AMx8x5B RTC Silicon Erratum ER0007 Version 1.2

1. Introduction

Figure 4. VCC high to nRST High ($t_{VH:NRST}$) Delay Extension

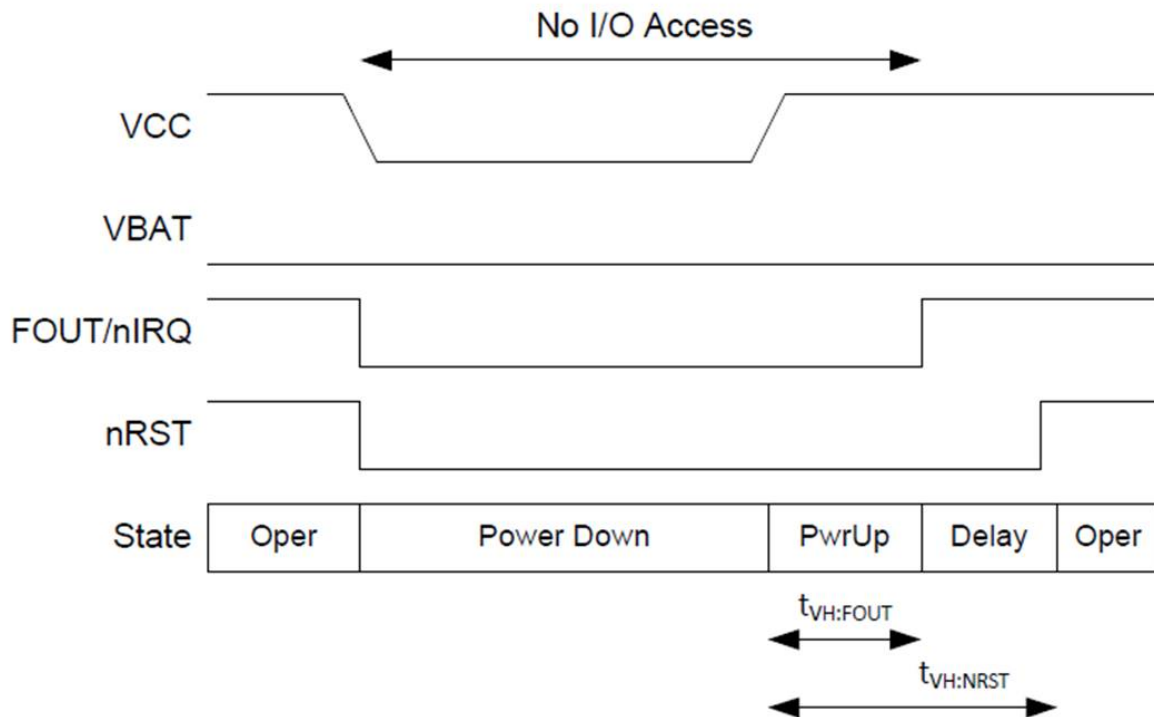
For the affected devices specified by this erratum, the delay to nRST high will be extended over the current datasheet specification due to different nRST delay timing on these devices. This increases the delay for nRST high after power-up reset ($t_{VH:NRST}$) as shown in Figure 4, *and* after exit from sleep (t_{RSTIM}) as shown in Figure 5, by an additional 100 – 300 ms.
